**Meeting:** 3/20/2025  
**Applicant:** Daniel Schuh, Knoxville Preservation and Development LLC  
**Owner:** Daniel Schuh, Knoxville Preservation and Development LLC

**Location:** 408 E. Oklahoma Ave. **Parcel ID** 81 L P 009  
**District:** Old North Knoxville H  
**Zoning:** RN-2 (Single-Family Residential Neighborhood)  
**Description:** Queen Anne cottage, c.1910

**3-F-25-HZ**  
**APPLICATION FOR CERTIFICATE OF APPROPRIATENESS**

**408 E. Oklahoma Ave. 37917**  
**Old North Knoxville H**

ROOF PLAN  
SCALE: 1/4"=1'-0"

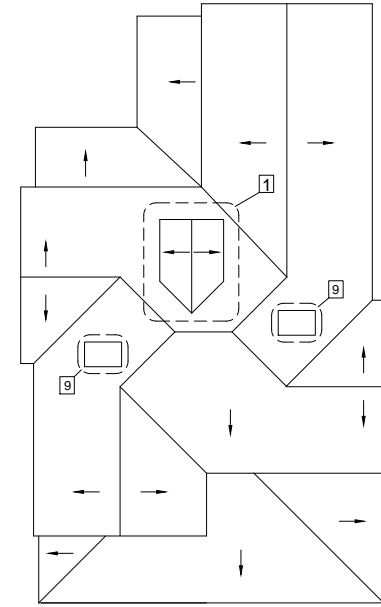
8. Skylights are typically discouraged if visible from the street, interfere with decorative roof elements, or shaped

so they project upward from the roofline. The left skylight will be somewhat visible from the street, and the right skylight will not be visible from the right-of-way. The skylights should be flush to the roof slope, with specifications submitted to staff for approval.

Staff recommends approval of Certificate 3-F-25-HZ, subject to the following condition: storm window specifications, porch railing detail, final window selections, and final skylight selections to be submitted to staff for approval.

DORMER  
SCALE: 1/2"=1'-0"

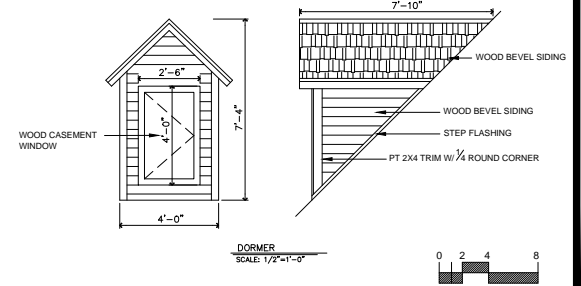
6. While the design guidelines discourage alterations to historic rooflines, new dormers have been approved on the rear elevations in ONK provided they are proportionate to the house, feature rooflines and materials aligned with the original house, and are minimally or not visible from the street. The proposed dormer meets these parameters and will not be visible from the street due to the house's roofline.
